BOLT, MACHINE - DOUBLE HEXAGON EXTENDED
WASHER HEAD, DRILLED, PD SHANK, NICKEL ALLOY,
UNS N07718, 185 KSI MIN., 3750-24 UNJF-3A

SAE AS3246
SHEET 1 OF 3

REV.
C

FIGURE 1 - BOLT

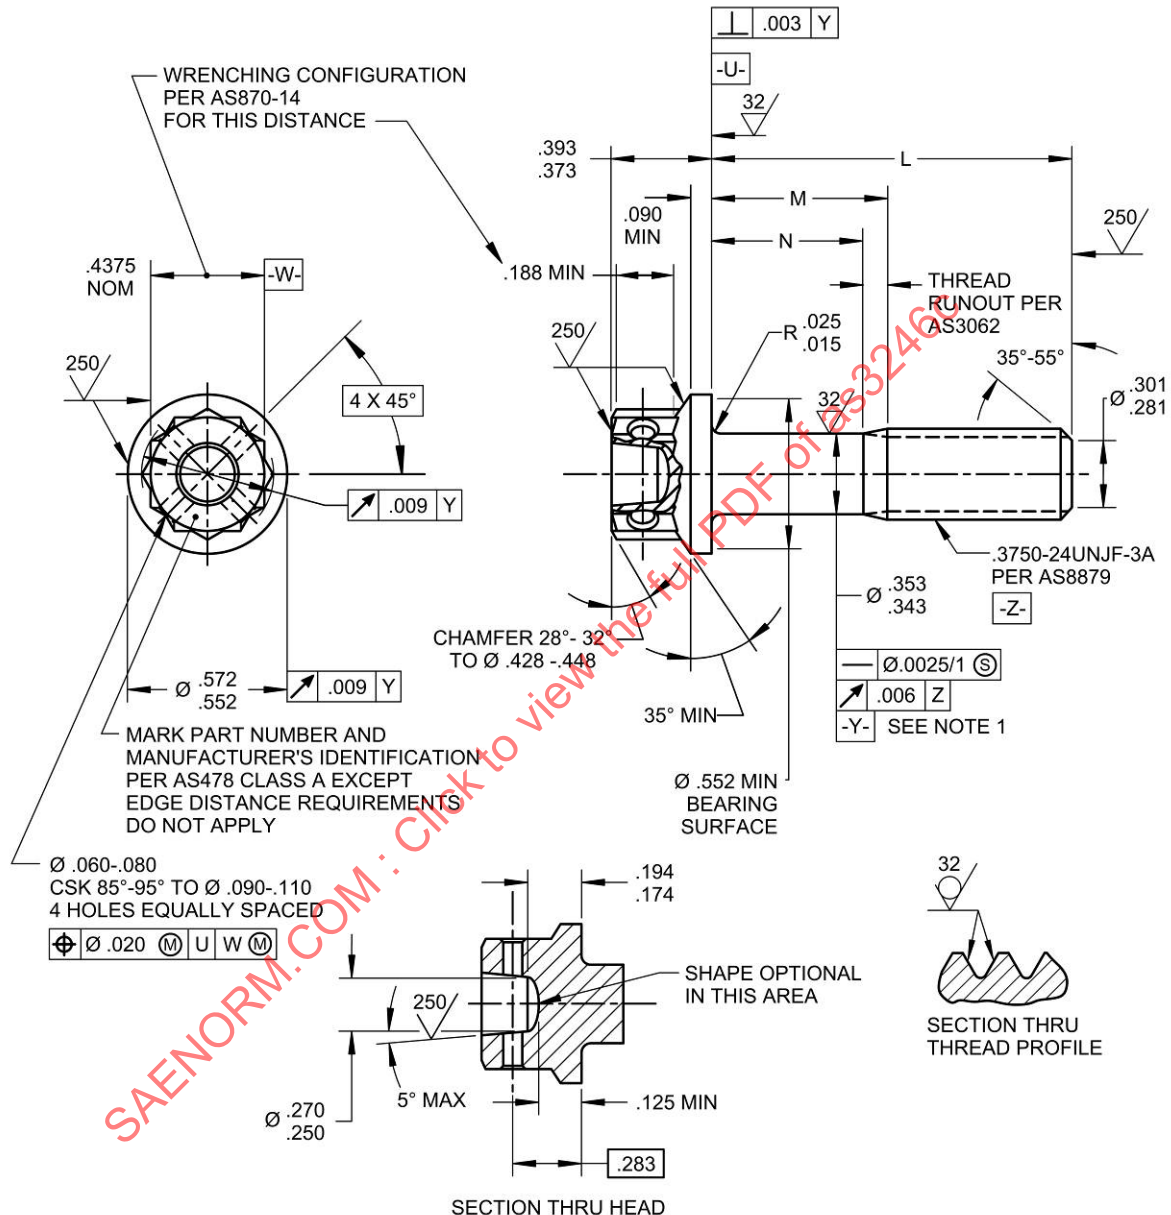
REVISE WRENCHING ELEMENT RUNOUT CALLOUT (RELOCATE FROM WRENCH FLATS TO POINTS). REVISE THREAD SPECIFICATION TO AS8879. REVISE LIGHTENING HOLE CONFIGURATION (ADD SECTION VIEW) TO ALLOW OPTIONAL SHAPE AT BOTTOM OF HOLE, ADD SYMBOL FOR Ø AND MMC TO POSITION TOLERANCE FOR SAFETY WIRE HOLES, DELETE .015 MIN RADIUS AT BASE OF WRENCH PAD, AND FIGURE 1 REDRAWN.
